FIELD CHANGE ORDER	NUMBER: PC736-F001, PC741-F001 PC743-F001, PC744-F001, PC746-F001
--------------------	--

APPLICABILITY: This "F" coded FCO should be installed on DECpc736, 741, 743, 744 and 746 computers at customer sites that require the BIOS support for 5.25", 360KB formatted diskettes. It will upgrade the PCs by replacing the BIOS ROM with revision level 1.22 on the Main Logic Board, P/N 54-22042-01.

Field Installation and verification Procedure for BIOS V1.22

Figure 1: Main Logic Board layout

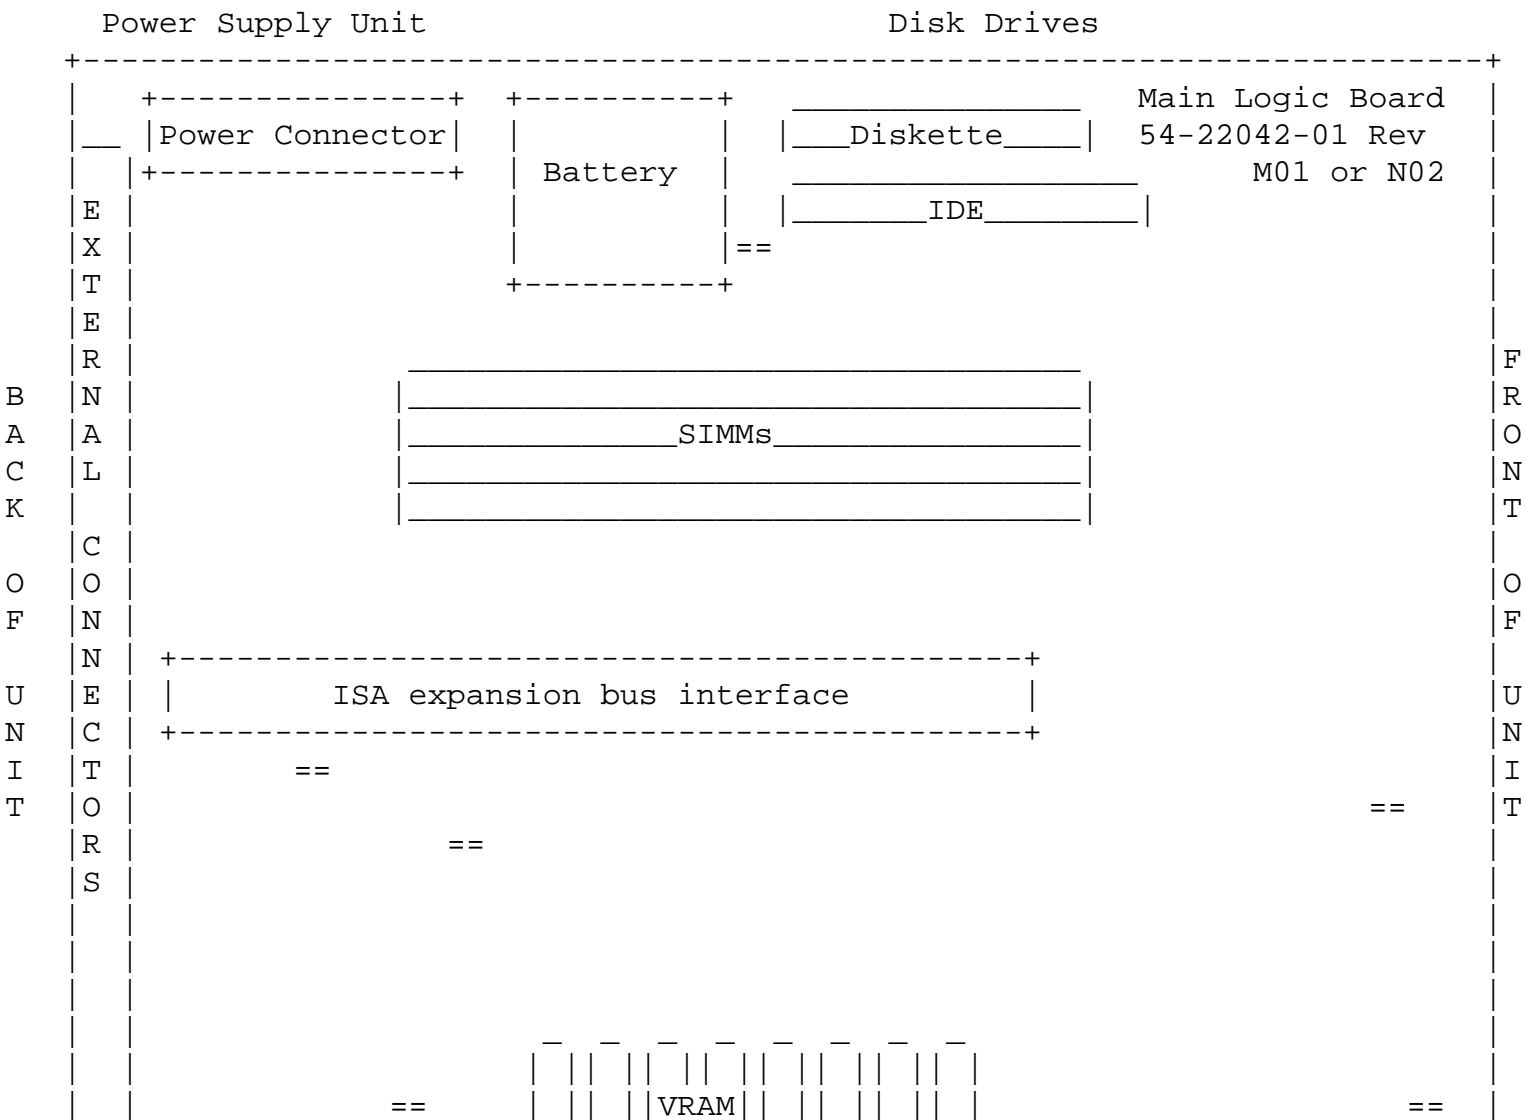
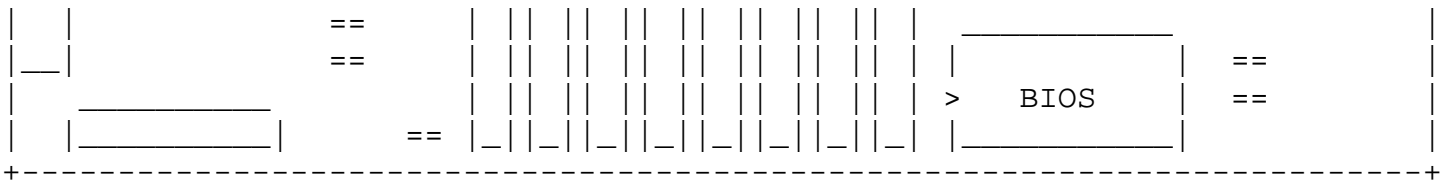
- Problem reading 5.25", 360KB formatted diskettes
- Disk type 34 and 35 do not comply with 85MB and 127MB Quantum drives
- NO extended printer support for NS87C311 & NS87C312
- Wrong polarity for V-SYNC and H-SYNC in 1024X768 display mode

6. Locate the BIOS ROM on the Main Logic Board. Refer to the following diagram for visual assistance: (The BIOS ROM is located on the left side of the Main Logic Board.)

SOLUTION: Replace the BIOS ROM in location E48 on the Main Logic Board 54-22042-01 with BIOS ROM, P/N 23-397E9-00 (BIOS V1.22).

- Use the chip extracting tool to remove the old BIOS ROM, pay attention to the chip orientation and make a note of which way the notch is facing. Replace it with the BIOS ROM V1.22 (23-397E9-00) supplied in EQ-01671-01. Pay particular attention to pin alignment and chip orientation when you are replacing the BIOS ROM. The notch on the ROM should face the back of the chassis, refer to Figure 1 on previous page for visual assistance. The notch on the chip is indicated by ">". Check to make sure there aren't any bent pins after you've replaced the chip.
